Plan Error, Resteel, Project 442(75) Cowan Lake

Drainage Details, Project 442(75)

CLI-730-0491
PROJECT 442(75)
CHANGE ORDER
11-5-75

Additional Drainage Details, Project 442(75), Cowan Lake

FOOTINGS AND DRAIN PLAN & JOINT TREATMENT DETAILS					
COWAN CREEK OUTFLOW UNDER CLI-730-0491					
DESIGNED	DRAWN	CHECKED	APPROVED	DATE	REVISION
AJM	AJM	GEA	SFG	1-14-15

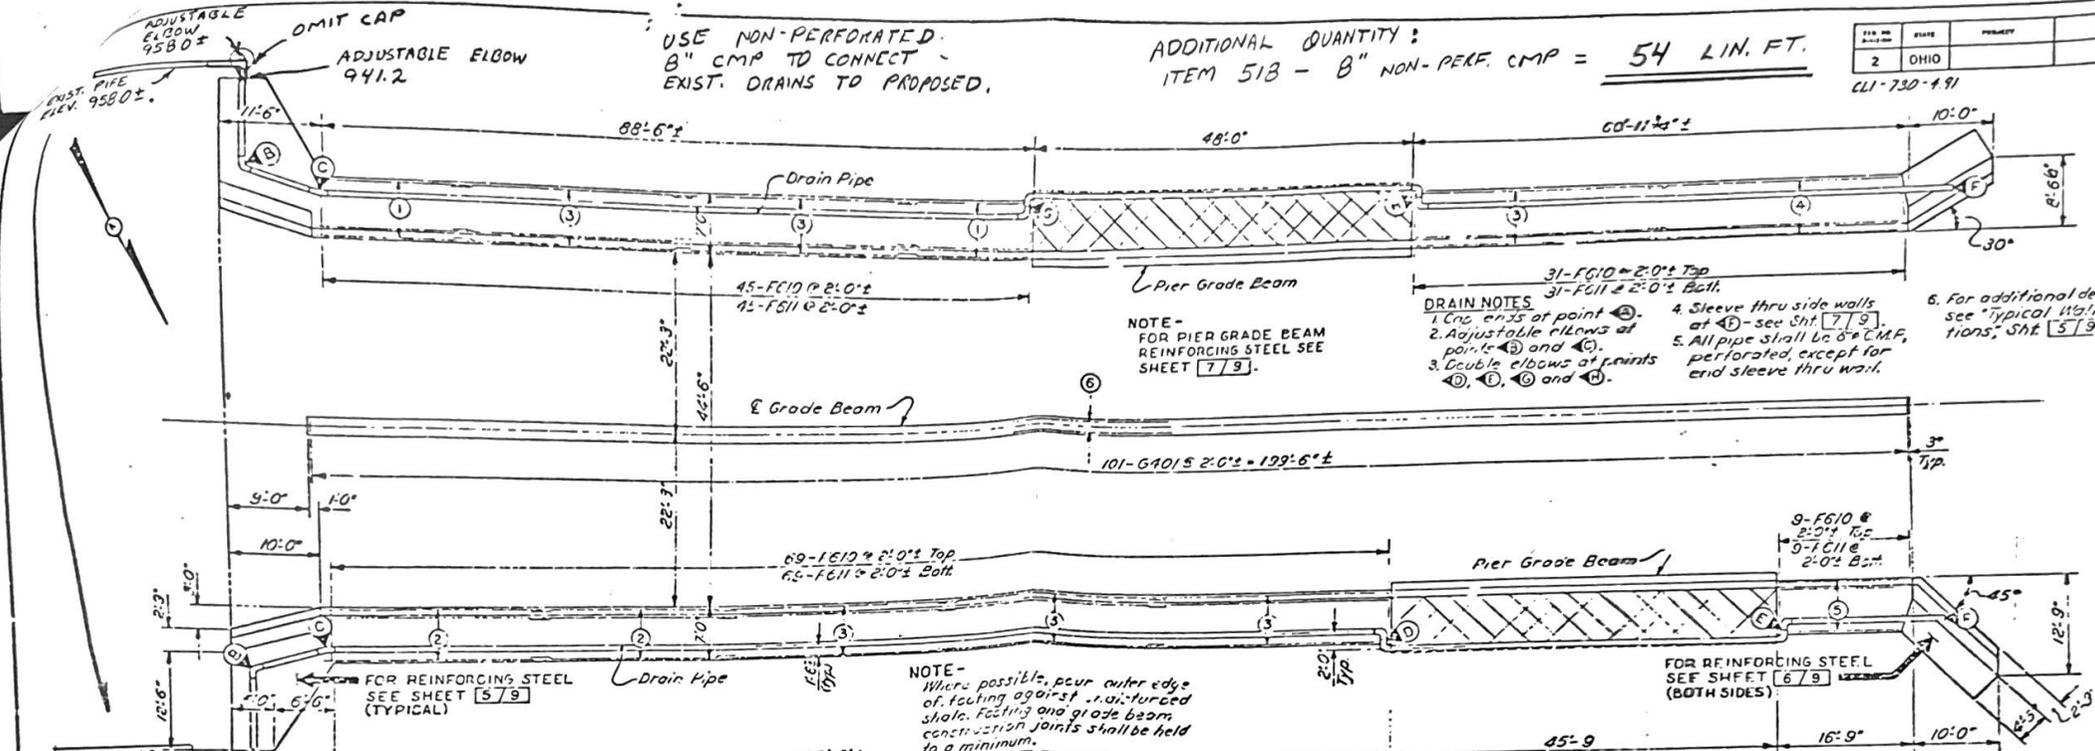
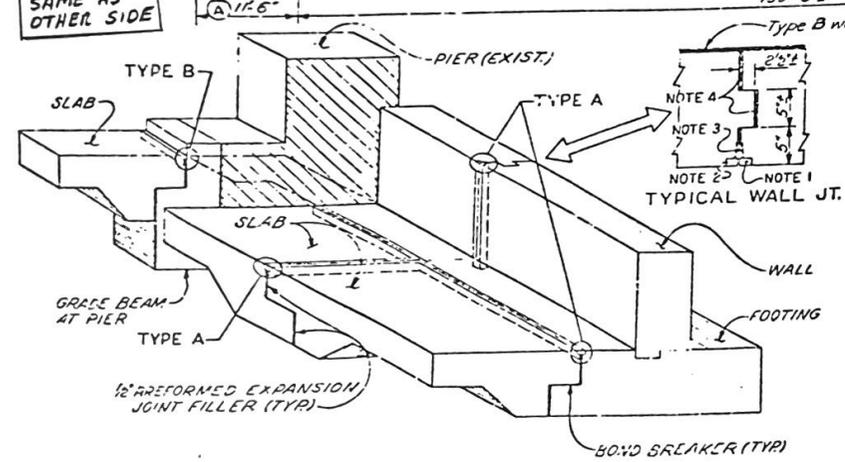
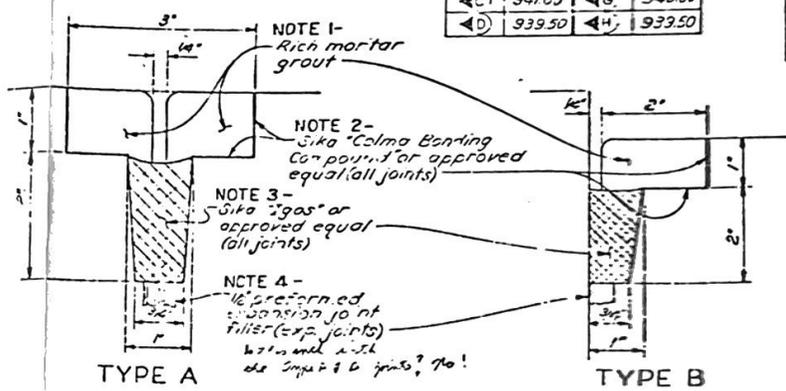
Attached herewith is a plan showing the connection of the existing drainage pipes behind the spillway walls to the proposed drainage system behind the flume walls. This arrangement was discussed with Mr. Grant at the site on this date.

USE NON-PERFORATED 8" CMP TO CONNECT EXIST. DRAINS TO PROPOSED.

ADDITIONAL QUANTITY:
ITEM 518 - 8" NON-PERF. CMP = 54 LIN. FT.

SITE PLAN

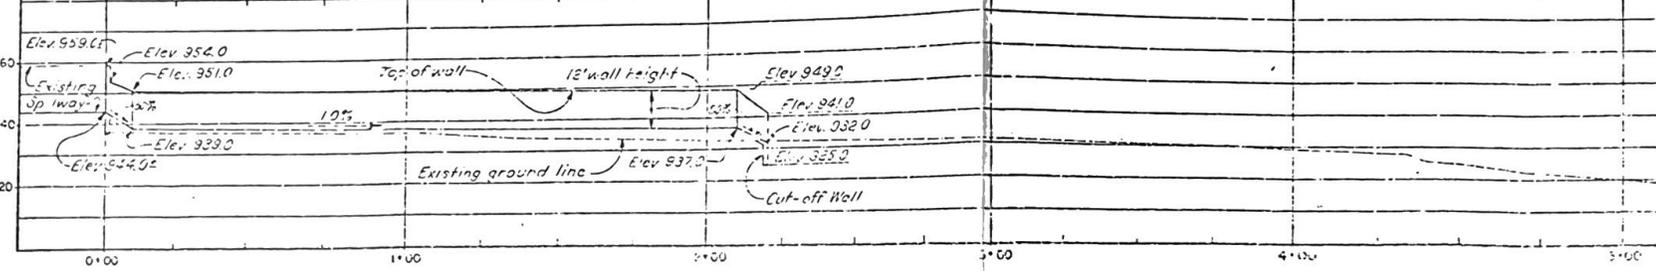
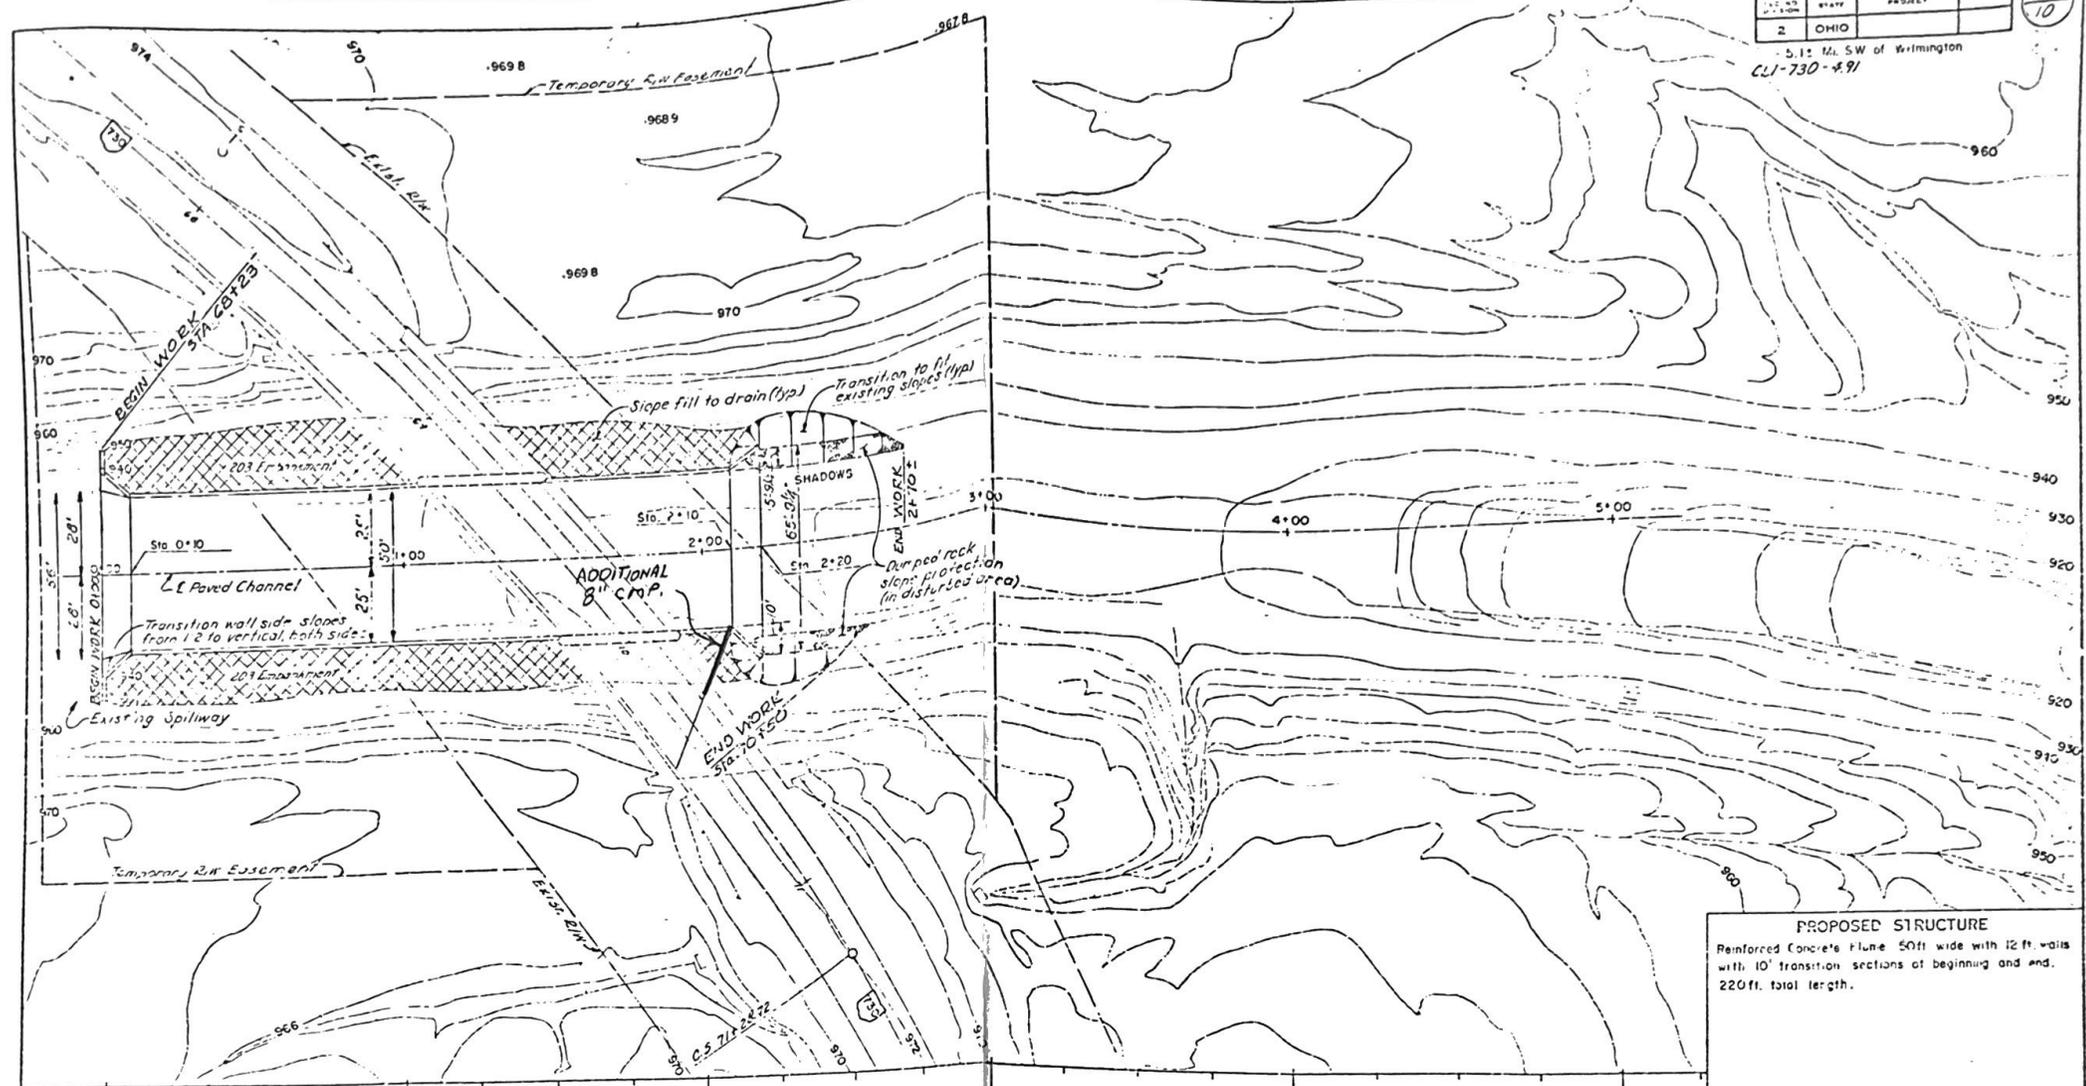
Attached herewith are sheets showing additional 8" corrugated metal pipe that we recommend to be used on the above project. We have conferred with Ray Keller and Adam Marcum (Bridge Bureau designer who drew the construction plans) about this extra work and they agree that it is needed. The work involves extending an existing CMP bridge deck drain at approximate STA. 2+00, 40' RT. so that it will drain into the proposed concrete flume instead of behind it.

NEW Y SECTION OF
CMP. WITH CAPPED END
SO THAT PIPE CAN
BE CLEANED OUT

CUT EXIST. 8" CMP,
HERE

NEW 8" NON-PERF. CMP.

FORM AROUND
NEW 8" CMP.

NEW
ADJUSTABLE
ELBOW

ADDITIONAL QUANTITY :

ITEM 518- 8" NON-PERFORATED
CMP, INCL. SPEC., 707.01, BITUMINOUS
COATED AS PER 707.04
= 28 LIN. FT.
